SUBJECT:	PRELIMINARY REPORT, Angus Glen Village Ltd., 4071 and 4289 Major Mackenzie Drive East, south side of Major Mackenzie Drive, west of Kennedy Road, Zoning By-law Amendment and Site Plan Control Applications to permit 173 townhouses on the subject lands, File No. ZA/SPC 18 154612 (Ward 6)
PREPARED BY:	Rick Cefaratti, MCIP, RPP, Planner II, West District, (ext. 3675)
REVIEWED BY:	Dave Miller, MCIP, RPP, Manager, West District, (ext. 4960)

That the report dated June 10, 2019 entitled “PRELIMINARY REPORT, Angus Glen Village Ltd., 4071 and 4289 Major Mackenzie Drive East, south side of Major Mackenzie Drive, west of Kennedy Road, Zoning By-law Amendment and Site Plan Control Applications to permit 173 townhouses on the subject lands, File No. ZA/SPC 18 154612”, be received.

FIGURE No. 4

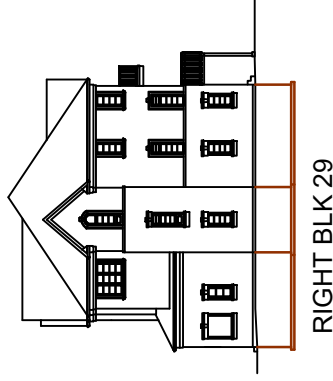
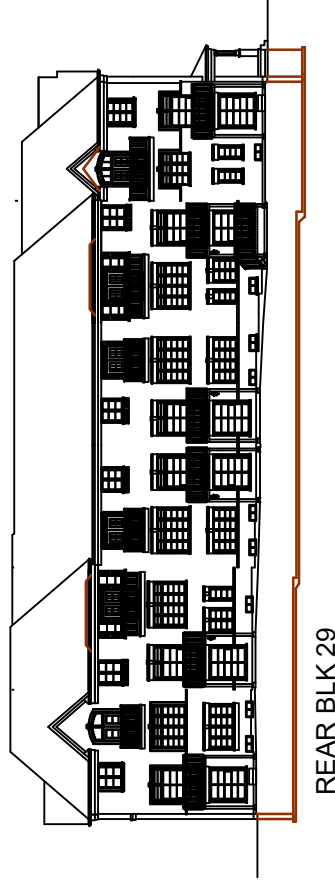
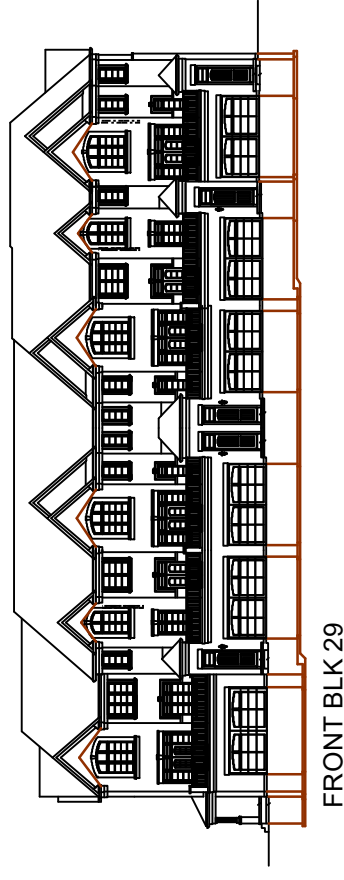
- a) The applicant should revise the site plan to orient townhouse units to front onto valley lands, parks and open space, to eliminate back lotting.
- b) The applicant should consider making some of the proposed townhouses more accessible by including layouts that support future elevators, provide main floor master bedrooms, and at grade entrances.

-
- c) A public access easement should be provided connecting from Major Mackenzie Drive through the central open space to the valley lands and trail system at the south end of the site.
 - d) Snow storage areas should be identified.
 - e) No parkland dedication is provided through this proposed development. However, a parkland dedication summary, submitted by the applicant, for all phases of Plan of Subdivision 19TM-03004, is currently under review by staff to determine whether there is a requirement for an additional contribution of parkland, or cash-in-lieu of parkland.

Engineering advises that stormwater management infrastructure and a retaining wall is shown within areas of the property that are proposed to be in public ownership. Engineering staff recommends that these components be relocated to areas that will remain in private ownership.

The Fire Department requires two independent street access points to Major Mackenzie Drive East. York Region Transportation staff will not allow a second connection to Major Mackenzie Drive East (see York Region comments provided below).

Waste Management staff is concerned about the ability of Waste Management vehicles to enter/exit the townhouse development via the private lane connection at the west end of the plan.

- a) York Region's Transportation Engineering staff has advised that the proposed west access to Major Mackenzie Drive East will not be permitted.

-
- b) The site plan drawings should be revised to demonstrate the proposed central full moves access, to Major Mackenzie, will align with the collector road identified in the Angus Glen Secondary Plan Area to the north, within the Future Urban Area.
 - c) A westbound left turn lane to the site from Major Mackenzie Drive with a 130.0 m (426.5 ft.) taper, 50.0 m (164.0 ft.) parallel lane, and a 15.0 m (49.2 ft.) minimum storage length with a width of 4.0 m (13.1 ft.), is to be provided.
 - d) An eastbound right turn lane from Major Mackenzie Drive East to the site with a 70.0 m (229.6 ft.) taper and a 40.0 m (131.2 ft.) storage length, is to be provided.
